**BUILDING PERMIT REPORT**

DATE: 24 Sept. 97  
 ADDRESS: 267 Maine St  
 REASON FOR PERMIT: Amenement to permit # 970978  
 BUILDING OWNER: Mary Dabail  
 CONTRACTOR: Gene Keller  
 PERMIT APPLICANT: Owner  
 APPROVAL:  $12 \times 16 \times 25 \times 30$   
 USE GROUP: R-3  
 BOCA 1996 CONSTRUCTION TYPE 5B

# APPLICATION FOR AMENDMENT TO PERMIT

The undersigned hereby applies for amendment to Permit No. 970978 pertaining to the building or structure comprised in the original application in accordance with the Laws of the State of Maine, the Building Code and Zoning Ordinance of the City of Portland, plans and specifications, if any, submitted herewith, and the following specifications:

# Drawing A

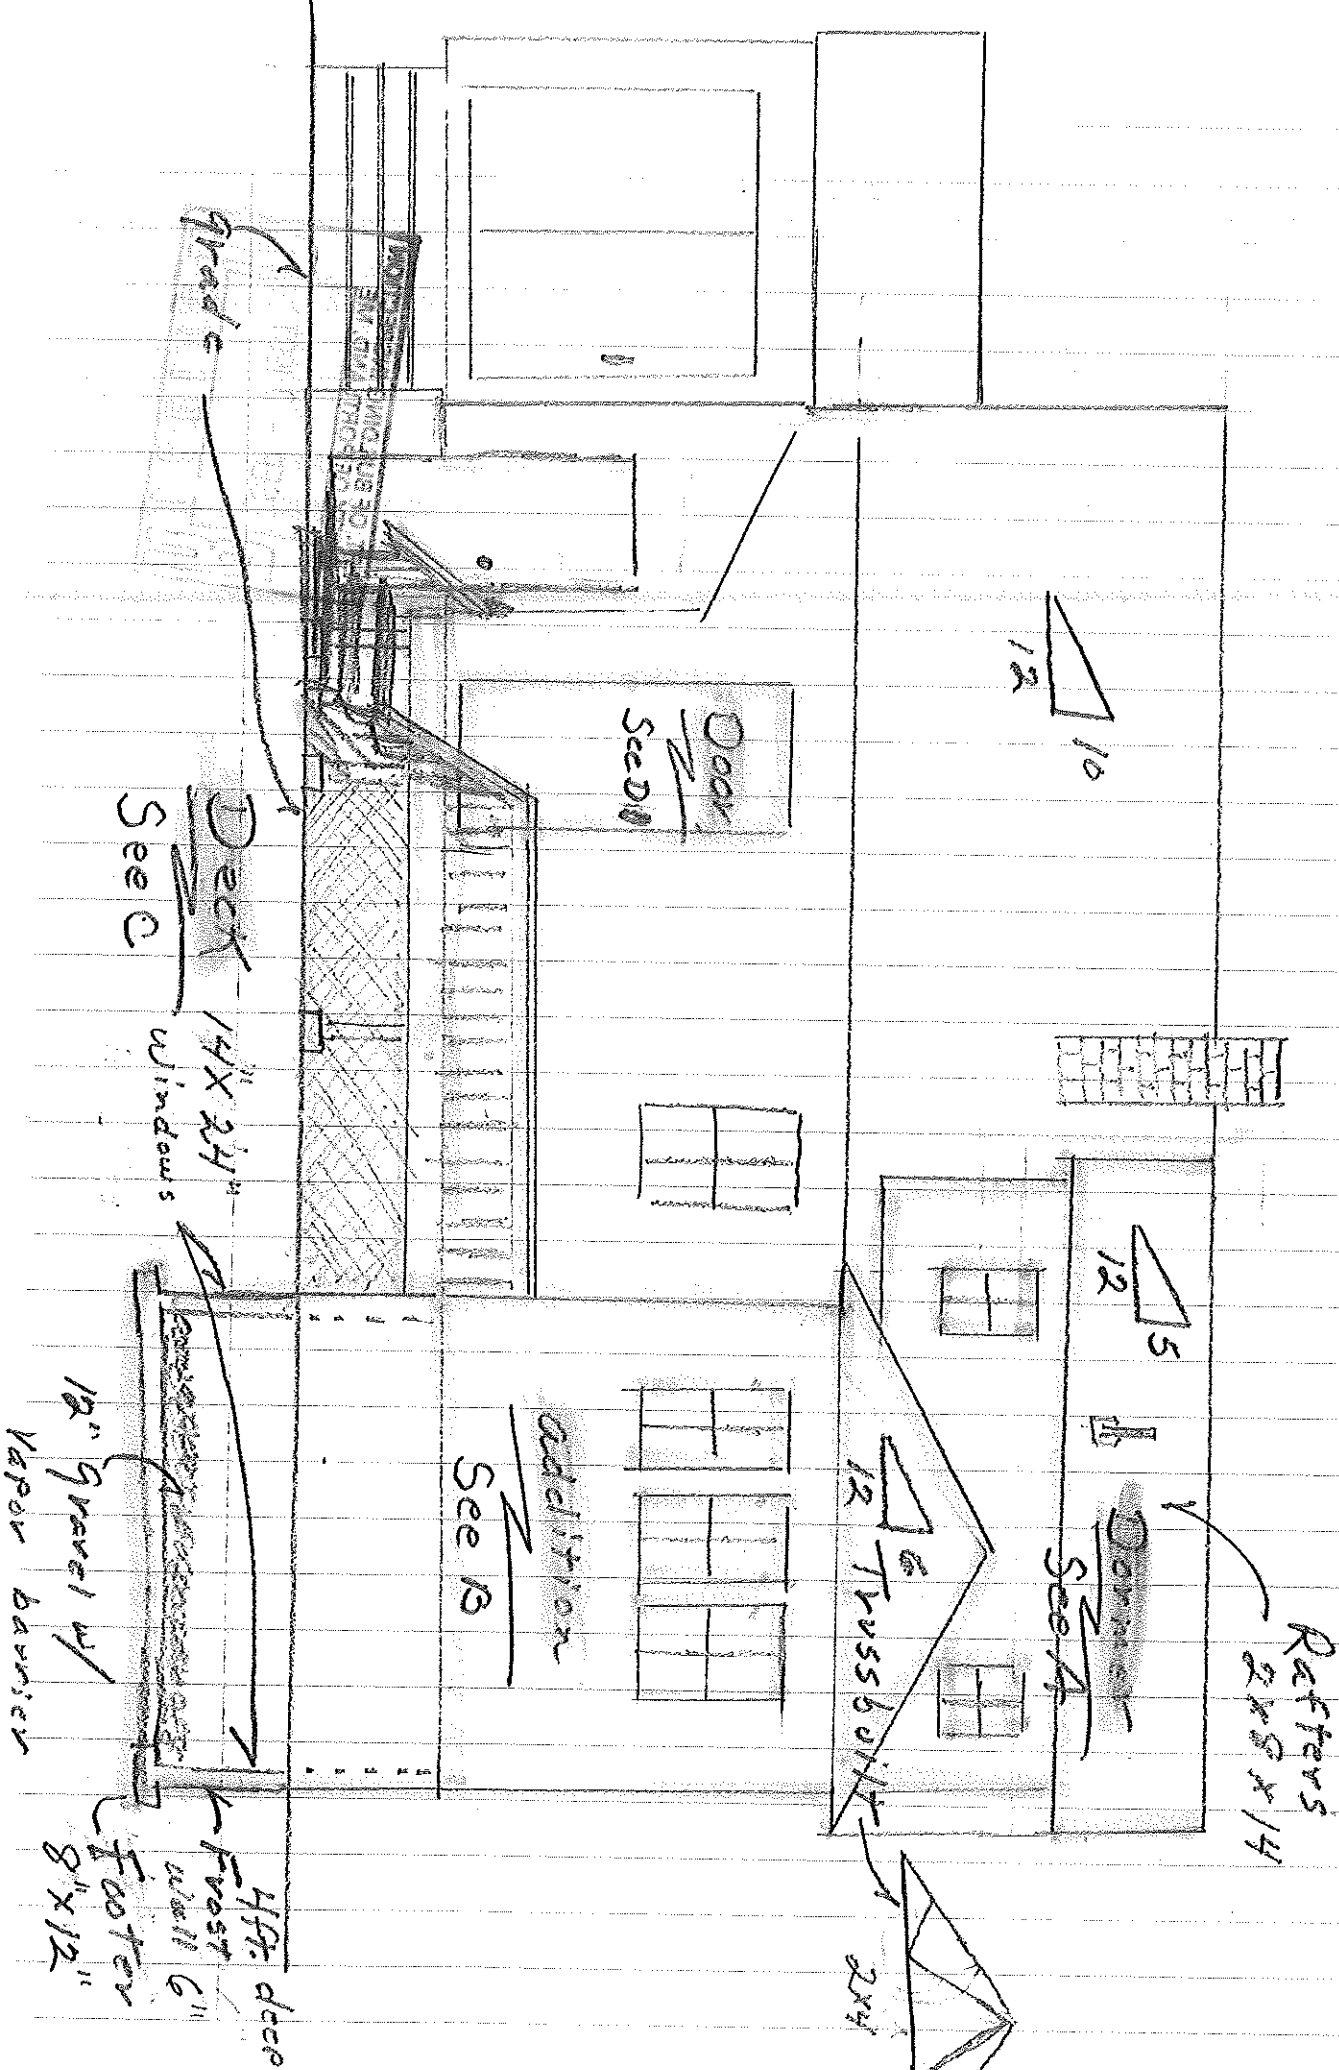
Convert from front wall to full foundation as per plans.

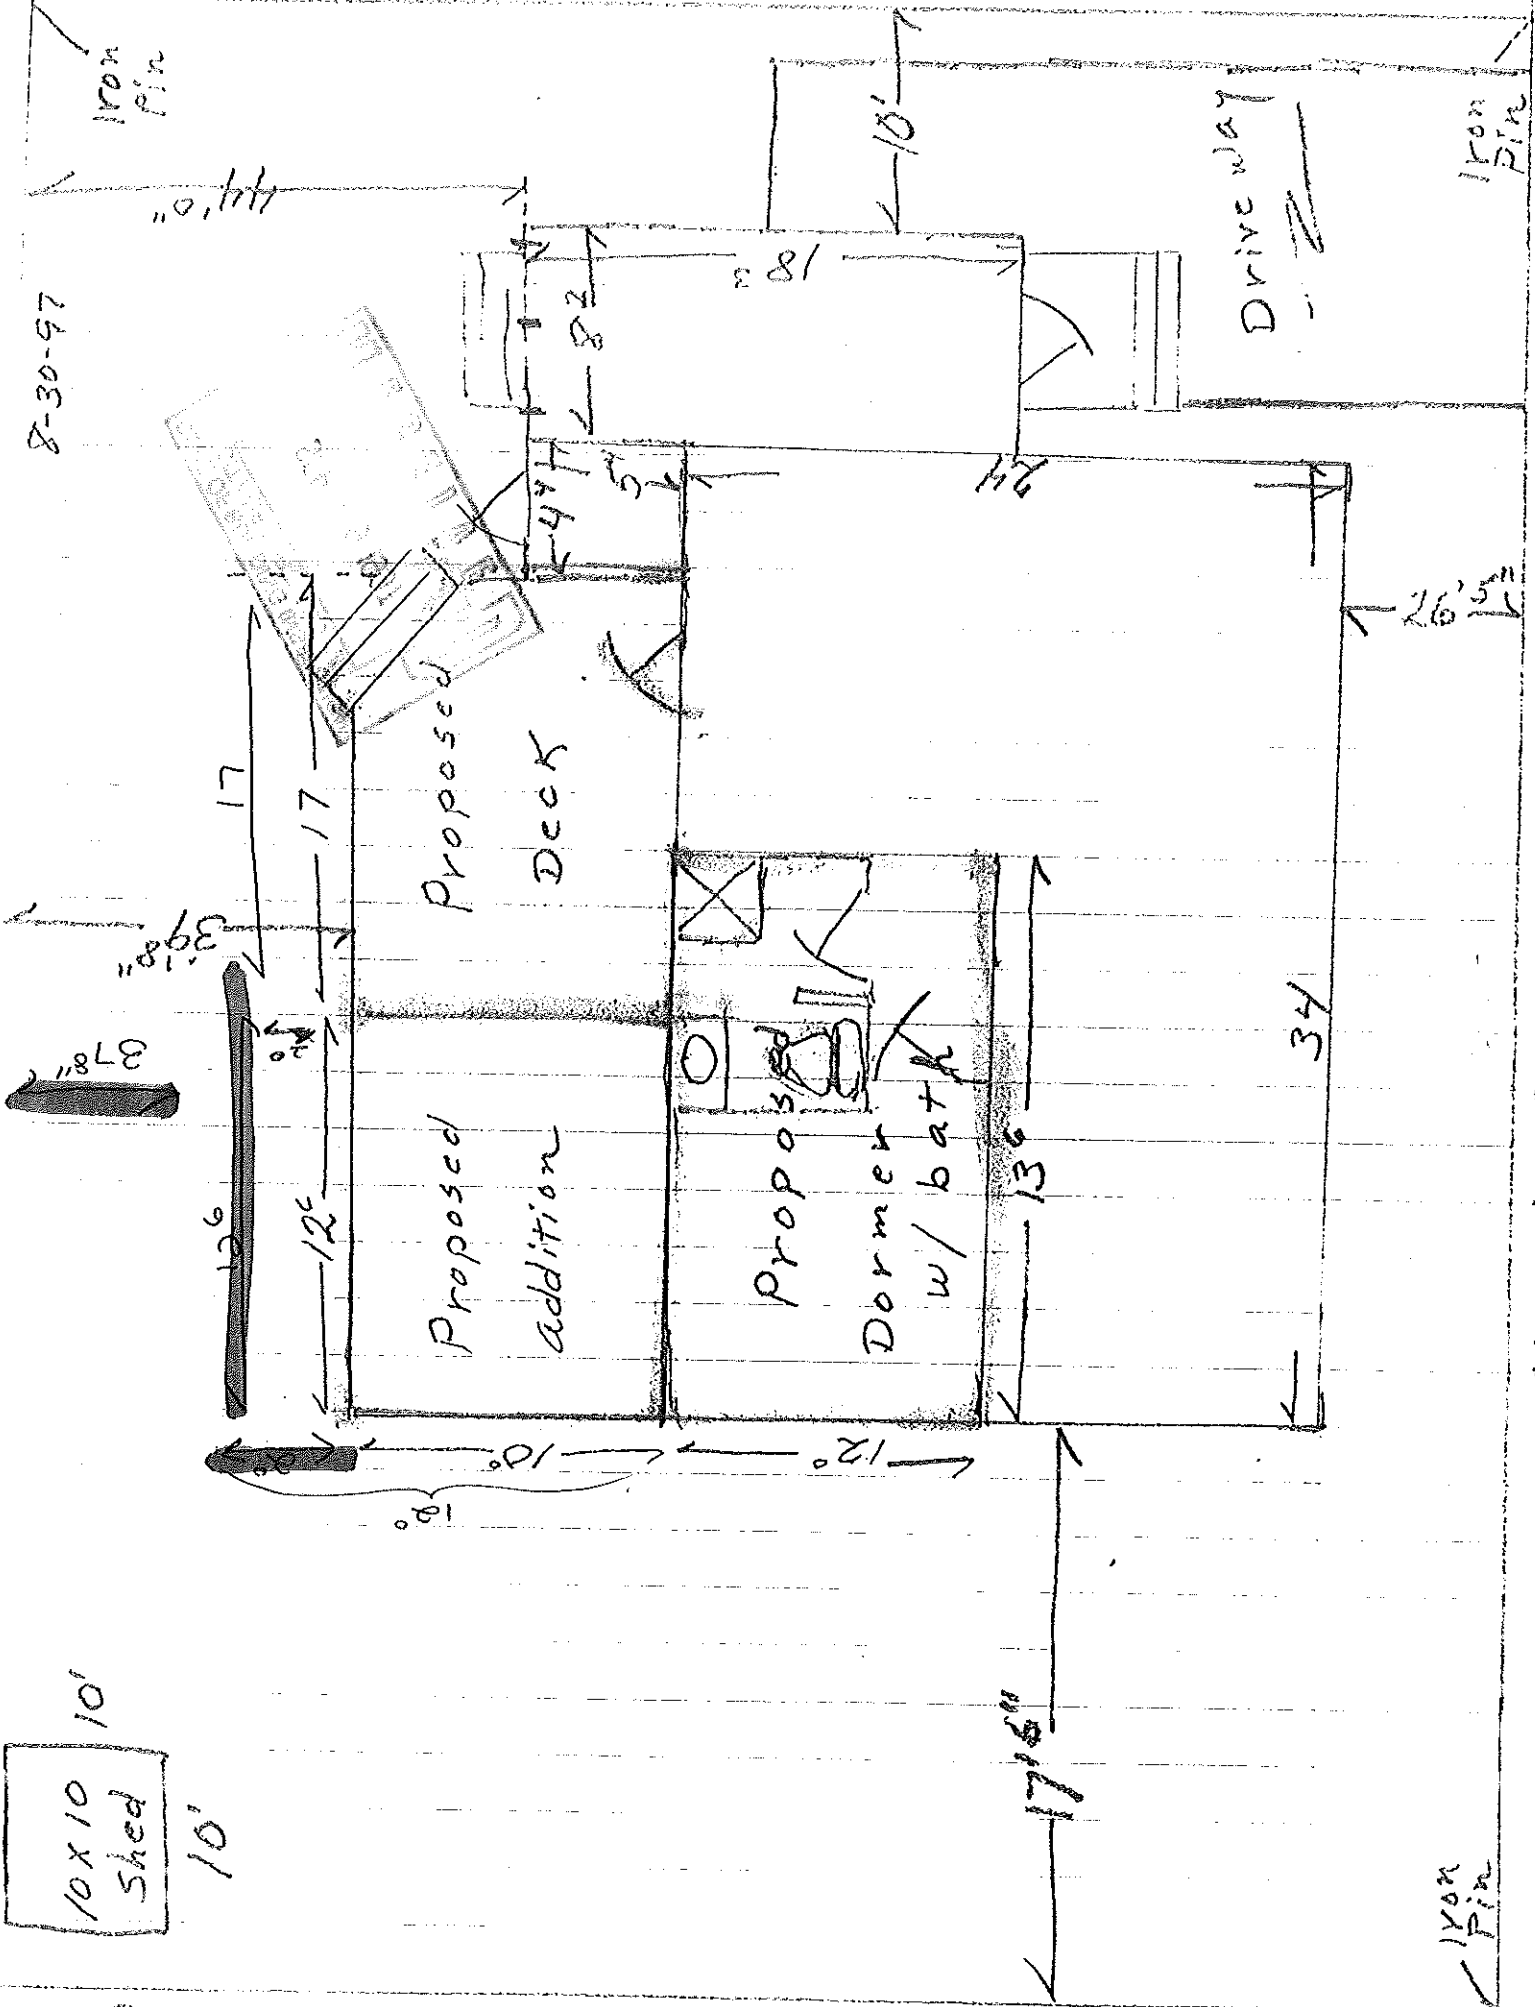
Extend addition (Proposed) additional 2'.
